Groundwater Application Review Summary Form

Application # G-LL-1799 (re-review)

TO: Water Rights Section Date 2/14/2020
 FROM: Groundwater Section Benjamin Scandella, Jen Woody
 Reviewer's Name
 SUBJECT: Application LL-1799 Supersedes review of 11/20/2019
 Date of Review(s)

A. GENERAL INFORMATION: Applicant's Name: **CHRIS RAMSEY; DOMAINE SERENE VINEYARDS AND WINERY INC.**
 County: **POLK**

Cross-section of nearby well logs, with water-bearing zones and approximate ranges of measured water levels.

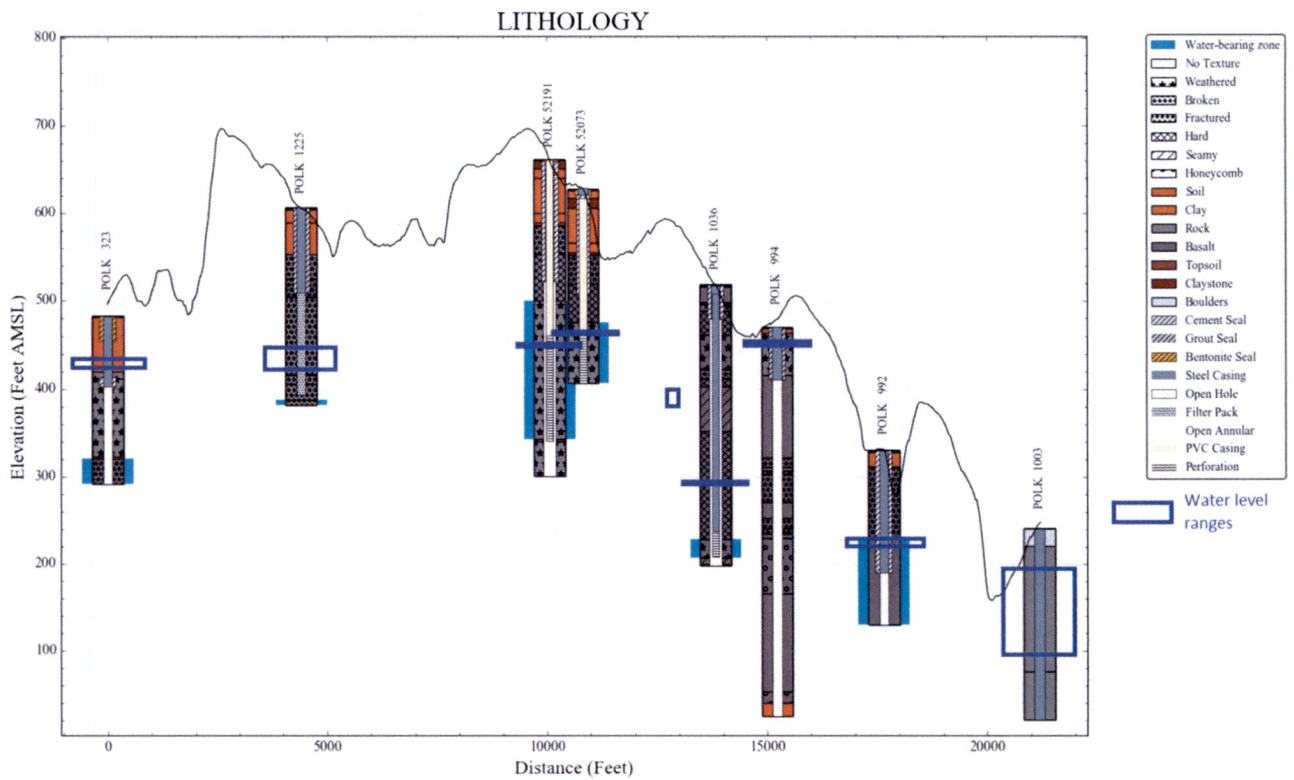
The nearest well to the subject well, POLK 994, is about ¼ mile away. However, the total depth of this well is almost 300 ft deeper than the water level recorded on the well log, so it is unlikely that this well would be injured by the proposed use.

This Drawdown and Recovery at r = 1320 ft From Pumping Well

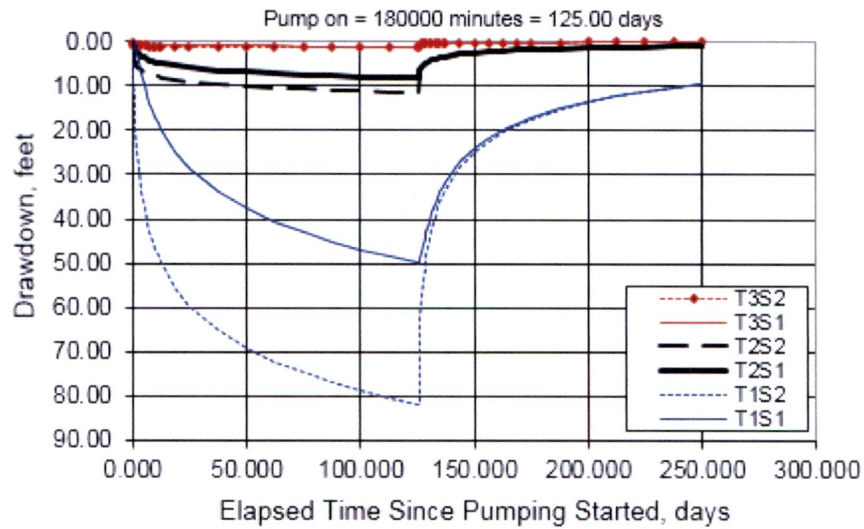
There are multiple springs with associated rights (Certificate Numbers 30528 and 31628) located approximately ¼ mile from the subject well. Analytic modeling using the Theis (1941) drawdown model with relevant parameters (Conlon and others, 2005, OWRD Groundwater Database, 2019) suggests that pumping at the proposed rate for 125 days could plausibly cause up to 80 feet of drawdown at the spring on Certificate 31628 (see figure below). The large range of plausible outcomes makes it difficult to determine whether the proposed use is likely to interfere with the spring and cause a senior user not to receive their entitled water. However, given the strong potential for injury to the certificated springs under the proposed rate, and the unknown sensitivity of the spring to drawdown, the Limited License should be conditioned as follows:

Special Condition: Water use under this limited license shall be shut off if either Certificate 30528 or Certificate 31628 does not receive the water to which it is legally entitled. Water use shall remain shut off until the following spring, unless it is specifically re-authorized by The Director.

Cross-section of nearby well logs, with water-bearing zones and approximate ranges of measured water levels.

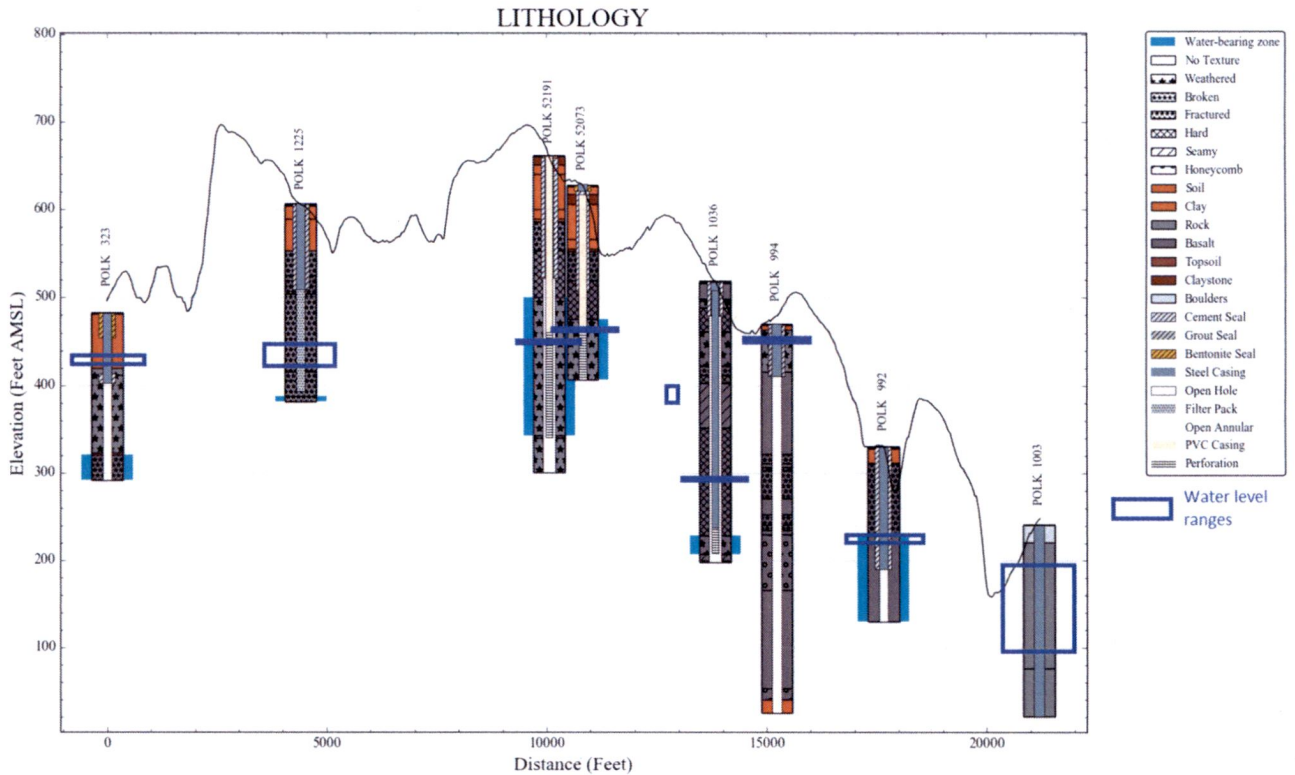
The nearest well to the subject well, POLK 994, is about ¼ mile away. However, the total depth of this well is almost 300 ft deeper than the water level recorded on the well log, so it is unlikely that this well would be injured by the proposed use.

This Drawdown and Recovery at r = 1320 ft From Pumping Well

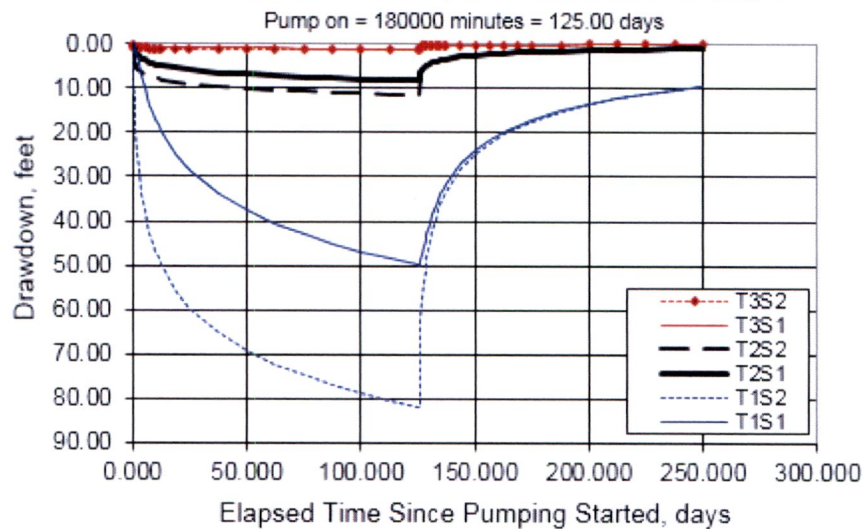
There are multiple springs with associated rights (Certificate Numbers 30528 and 31628) located approximately ¼ mile from the subject well. Analytic modeling using the Theis (1941) drawdown model with relevant parameters (Conlon and others, 2005, OWRD Groundwater Database, 2019) suggests that pumping at the proposed rate for 125 days could plausibly cause up to 80 feet of drawdown at the spring on Certificate 31628 (see figure below). The large range of plausible outcomes makes it difficult to determine whether the proposed use is likely to interfere with the spring and cause a senior user not to receive their entitled water. However, given the strong potential for injury to the certificated springs under the proposed rate, and the unknown sensitivity of the spring to drawdown, the Limited License should be conditioned as follows:

Special Condition: Water use under this limited license shall be shut off if either Certificate 30528 or Certificate 31628 does not receive the water to which it is legally entitled. Water use shall remain shut off until the following spring, unless it is specifically re-authorized by The Director.

DOMAINE SERENE DEEP ROCK VINEYARD LIMITED LICENSE APPLICATION MAP

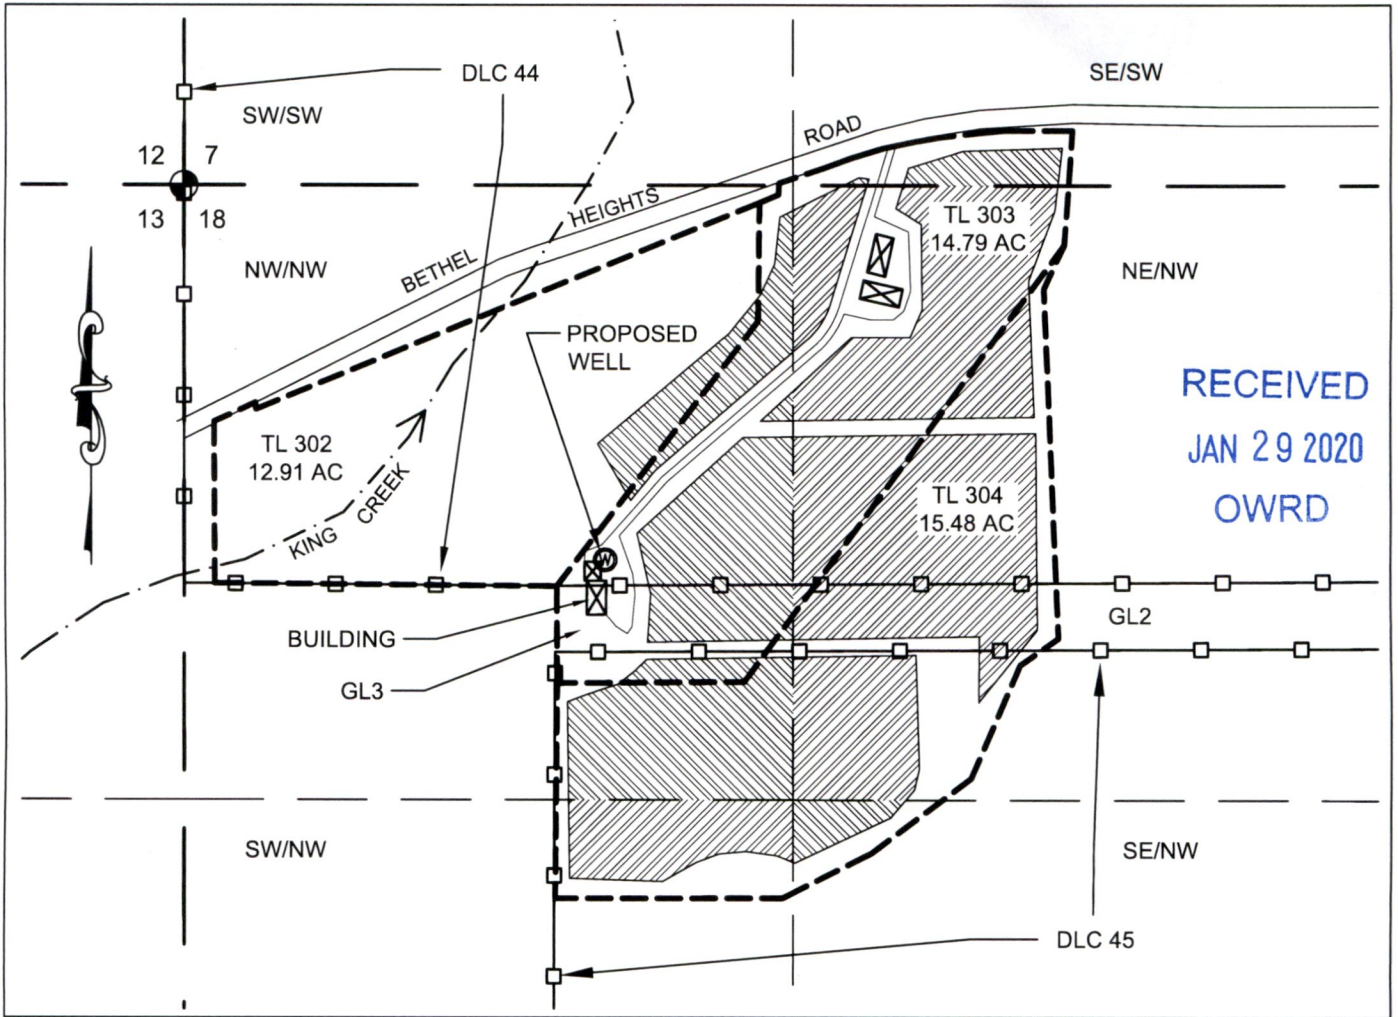
NOTE: THIS MAP IS REVISED TO SHOW LOCATION OF A PROPOSED NEW WELL. THIS APPLICATION FOR A LIMITED LICENSE IS BEING REVISED TO USE A NEW WELL AS THE WATER SOURCE. THE NEW WELL WILL BE LOCATED 20 FEET SOUTH AND EAST OF THE EXISTING WELL POLK 1036.

POD, PROPOSED WELL #2 IS LOCATED 910' EAST AND 810' SOUTH OF THE NW CORNER OF SECTION 18.

First I would like to ask for the new well to be 20 to 25 feet south west of the existing well. Just to allow them a little more distance from the existing well. The coordinates already submitted are close enough.
